DEVELOPMENT ASSESSMENT REPORT				
Application No.	DA/2020/0489			
Address	8 Richards Avenue MARRICKVILLE NSW 2204			
Proposal	Alterations and additions to existing dwelling			
Date of Lodgement	29 June 2020			
Applicant	Mr John Moshonis			
Owner	Mr Eddy Younan Mrs Jocelyn Younan			
Number of Submissions	One objection			
Value of works	\$80,000			
Reason for determination at Planning Panel	Clause 4.6 variation exceeds 10%			
Main Issues	<ul style="list-style-type: none"> • Non-compliance with Clause 4.4 Floor space ratio, Request for variation to development standard Clause 4.6 not submitted • Visual bulk • Neighbouring amenity impacts (Privacy) 			
Recommendation	Refusal			
Attachment A	Reasons for refusal			
Attachment B	Draft conditions (if not refused)			
Attachment C	Plans of proposed development

This report is an assessment of the application submitted to Council for alterations and additions to an existing dwelling at 8 Richards Avenue, Marrickville.

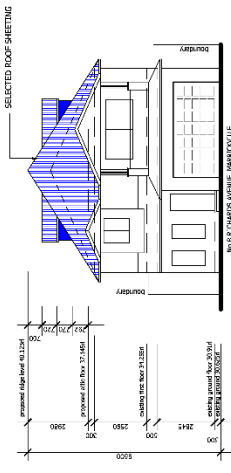
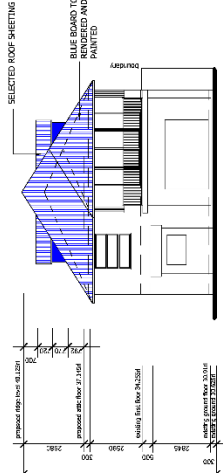
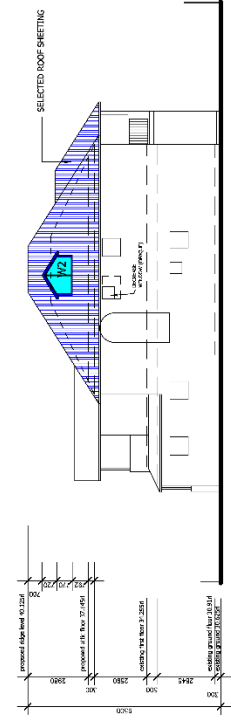
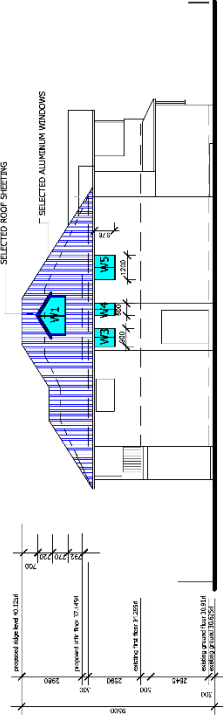
The proposed third storey includes dormer windows, with a sill height of 800mm and face the side boundaries. The proposed third floor windows fail to comply with C3, which require first floor windows and balconies to face the front or rear of the building, and/or the provision of privacy measures such as minimum sill heights of 1.6m, or fixed opaque glazing.

Given the windows service a third floor, the potential for overlooking is significant and unresolved by the design, and therefore the proposal fails to satisfy the relevant objectives.

The proposal includes two side-facing dormer windows to service the third storey. Control C40 allows the use of dormers in contemporary buildings to be determined on merit. Given their lateral expanse and direct presentation to the street, the proposed dormers are considered to dominate the roof plane and appear as a full third storey, contrary to Control C41. In accordance with Control C43, it is considered that dormer windows do not suit the architectural style of the building as they do not utilise existing roof space and create a complex roof form which is not sympathetic to the existing dwelling. Furthermore, contrary to C51, the use of dormers is considered inconsistent with the other existing roof forms in the street.
